Report: TAB REPORT
Function: Test, Adjust, & Balance
Date: 06/20/2024

PROJECT
06-17-24 CULVERS - STURTEVANT, WI
(REIMAGE)

Project: 06-17-24 CULVERS - STURTEVANT, WI (REIMAGE)

RTU_2_kitchen_
06/20/2024

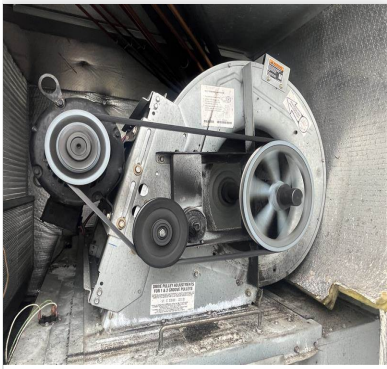
Issue Name : 02. RTU-2 (Kitchen): Low on Supply Airflow
Description : RTU-2 is a 15 ton unit and is supplying 3503 cfm to the kitchen space. For performance and efficiency, blower should operate at around 350 cfm/ton, or 5250 cfm. Per Staff, kitchen is not achieving or maintaining set temp. The RTU is installed with a curb adapter, which may be restricting airflow. Recommend airflow is increased on this unit.
Created By : National TAB **Assigned To :** National TAB - Will Turnbough
Status : Open
Priority : High **Asset Tag :**
Originated Date : 06/20/2024 - Michael McDonnell - National TAB

- **06/20/2024 National TAB - Michael McDonnell**
 - The motor sheave is frozen at 1-2 turns open and could not be adjusted to increase the speed of the fan. Recommend sheave is broken free and set to 1 turn open. Regardless, a pulley change will be required to bring the RTU closer to an efficient airflow. The motor is operating at 7.8 amps with an FLA rating of 14.6, so there is room to increase fan speed. Recommend pulley change is performed to increase airflow, consult NTAB.

4_way_diffuser
06/21/2024

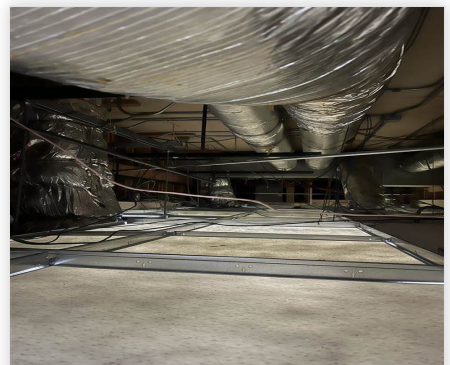
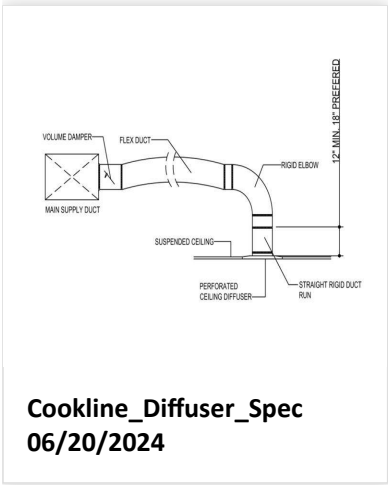
Issue Name : 03. COOKLINE DIFFUSERS
Description : There are three 4-way diffusers installed on the cookline. Recommend these are replaced with perforated diffusers (especially if RTU-1 airflow is increased). Store reports high temps during operation. Recommend 3 additional perforated diffusers are installed on the cookline to increase airflow to cookline, while avoiding hood capture issues.

- **06/20/2024 National TAB - Michael McDonnell**
 - Anticipate increasing RTU-2 airflow will cause hood capture issues with 4-ways. Recommend replacing 4-ways with perforated and installing according to Culvers Cookline Diffuser Specification. This entails a rigid elbow and 12-18" of straight rigid duct between the elbow and diffuser. See detail attached.

RTU_2_OA_FILTERS
06/20/2024

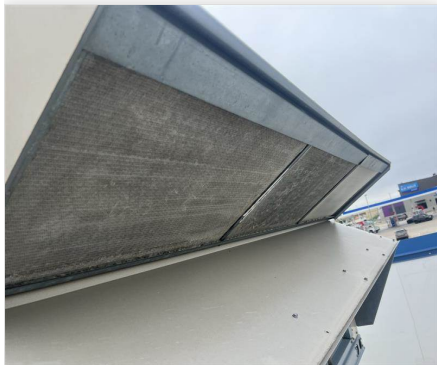
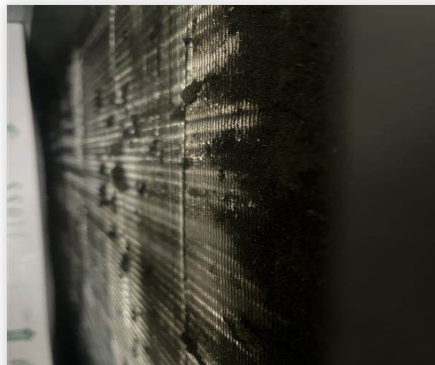
Issue Name : 04. RTUs: In need of Cleaning / Maintenance
Description : Both RTUs are in need of maintenance/cleaning. Evaporator coils, specifically on RTU-1, are in need of cleaning. Additionally, outside air filters need to be cleaned. See other items in need of attention below:
Created By : National TAB **Assigned To :** National TAB - Will Turnbough
Status : Open
Priority : High **Asset Tag :**
Originated Date : 06/20/2024 - Michael McDonnell - National TAB

**RTU_2_Condensate
06/20/2024**

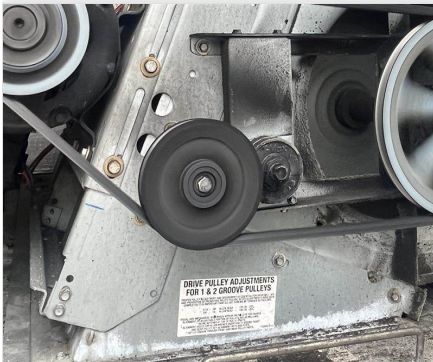
Issue Name : 07. RTU-1: Condensate Drain Routing
Description : Condensate drain on RTU-1 is directed toward roof drain. However, drain is easily clogged and water is pooling on the roof. Recommend drain is routed directly into roof drain as with RTU-2 so water does not pool and potentially leak into store space. See photos below.
